Gas Measurement Integrity Audits

Israel Natural Gas Lines (INGL)

AOT Custody Transfer Gas Audit May 2022

Document Reference: MK4266 - 002

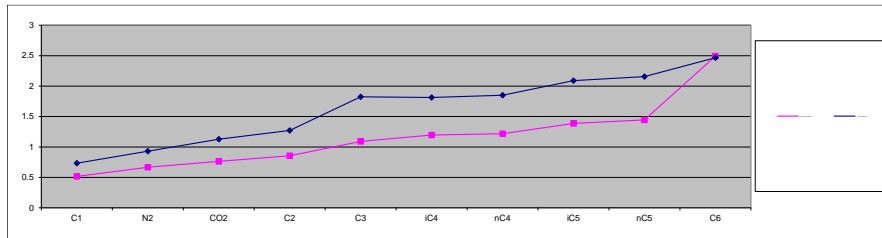
1. Serial number correlates with supplied data. A second GC was noted at the metering system, which is awaiting fitting in the near future. This should give increased gas quality measurement confidence due to increased redundancy. **(Comment)**
2. It is not clear if probe has been inspected. This task is typically set at a 5 year frequency. **(Comment)**
3. Some low points, as such not fully compliant with ISO-10715. However, no issue with drop out reported. See photos of set-up below:

4. No issues noted. Indicator covers starting to get opaque and after time it may not be possible to see values. No condensation/icing noted on sample conditioning. **(Comment)**

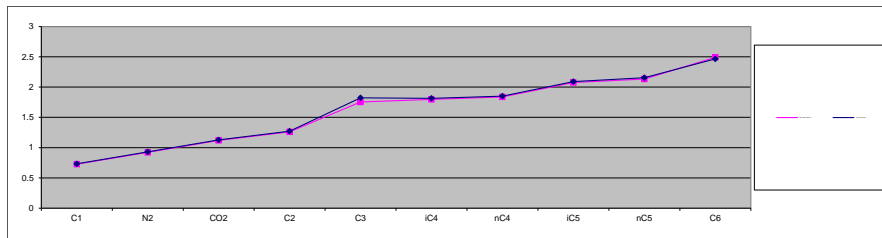
From the above facility it was noted that there was a step change in the C6+ element benchmark – see below:

However, if more recent data than the 2018 data than that used in the example above, the benchmark trend shows better results. See below results using data from June 2021:

Therefore the in use GC RF benchmark plot is unrepresentative.

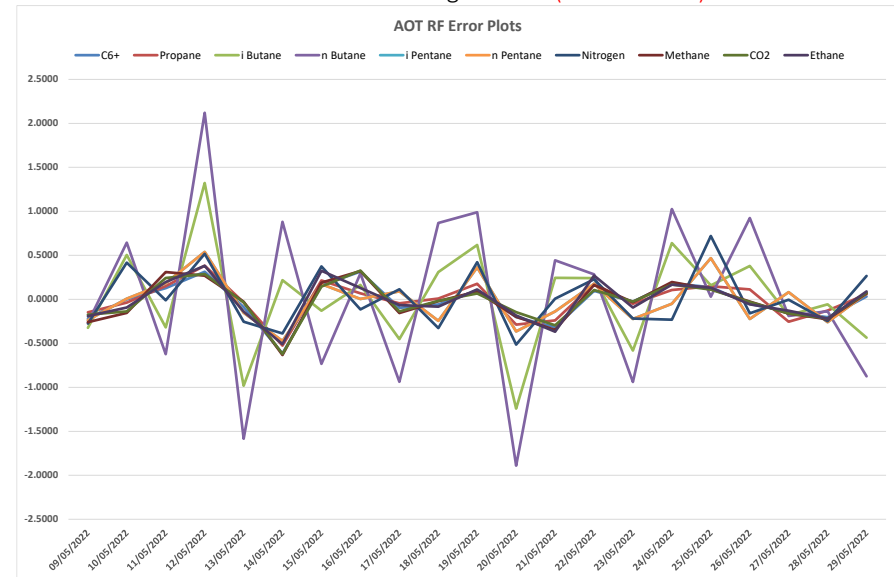
It can be seen from the graph of RF errors below that there are some asynchronous trends for some components. The trends that are deviating most are the heavier end components which have very small concentrations and therefore measurement risks should be mitigated. However, it is recommended to carry out some repeatability tests (compliance as per ASTM D1945-14 - 2019) to ensure there are no event or valve timing issues. **(Risk Factor 3)**

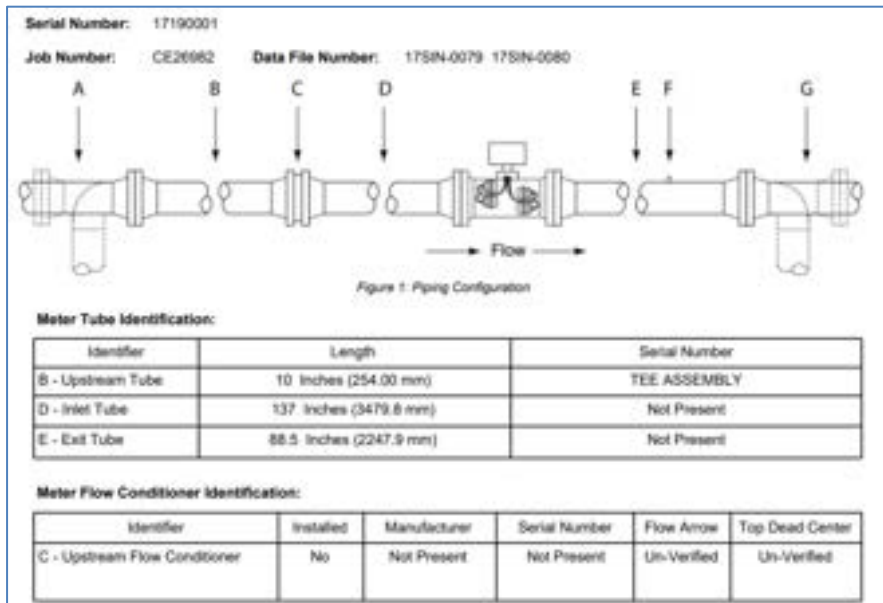
1. Serial numbers correlate with supplied certificates; however, whilst there were stated IDs on the wet calibration certificates, there were no formal dry metrology documents as per the requirements of the standards to show traceability to the IDs of the USMs. (Risk Factor 3)
2. ~15D from bend/blank flange to first USM (duty). This complies with vendor specifications and OIML R137, but not AGA-9. There are no flow conditioners fitted. (Comment)

3. As seen from photo above - No insulation fitted; however, the metering skid is not exposed, and the observed velocities were ~20 -24 m/sec, which should not result in any thermal gradient issues.
4. No issues visually noted with cabling.
5. See comment 2. Additionally, from the CEESI calibration certificate information it can be seen that the set up appears representative of the site configuration – see excerpt from one certificate example below:

Lengths B+C above result in ~15D which correlates with the upstream lengths observed during the audit. However, from the above it can be seen that only one meter is present. (Comment)

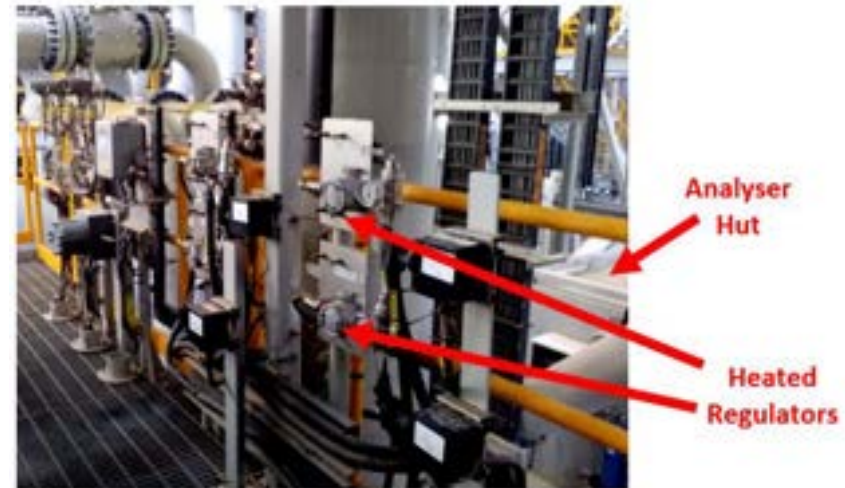
1. Serial number correlates with supplied information.
2. No issues noted. Site has not yet been in operation for more than 5 years so inspection not yet required. Oracle maint system not checked to verify if this task is scheduled at 5 yearly. **(Comment)**
3. See photo below of sample conditioning and analyser hut. As the probes and sample conditioning are above the analyser hut it is not compliant with ISO-10715. It was reported however, that there have been no issues with component drop-out. Sample lead time reported as estimated as ~10 minutes. **(Comment)**

4. Flows and pressures appear to be satisfactory during site visit. However, the sample conditioning system heated regulators not working, this issue is known,

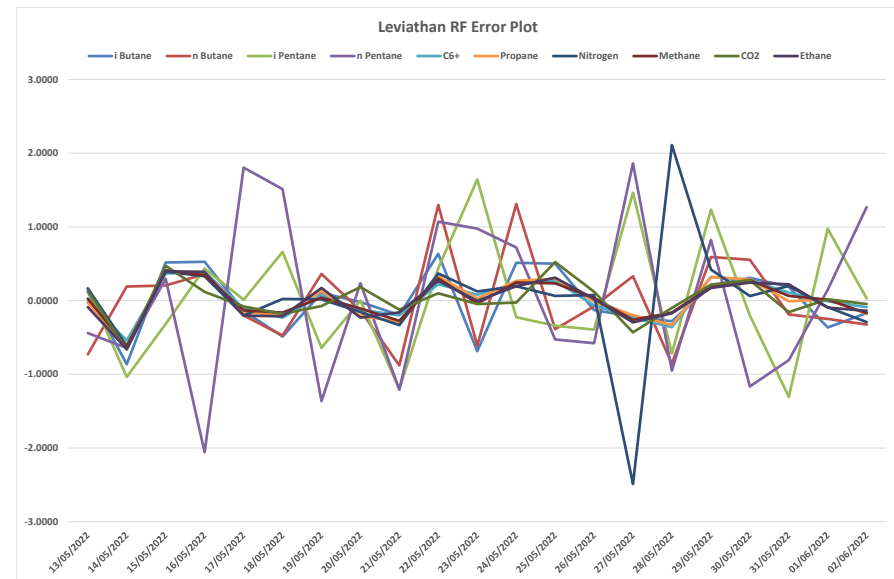
6. Effectech gas in use and supplied certificate data correlates with Component Table 1 in MON2020. Representivity appears to be satisfactory. The in-use gas expiry date is in July 2022; however, a spare bottle is available. See photo of calibration gas and carrier gas setup below. Helium carrier gas bottles 99.9995% purity.
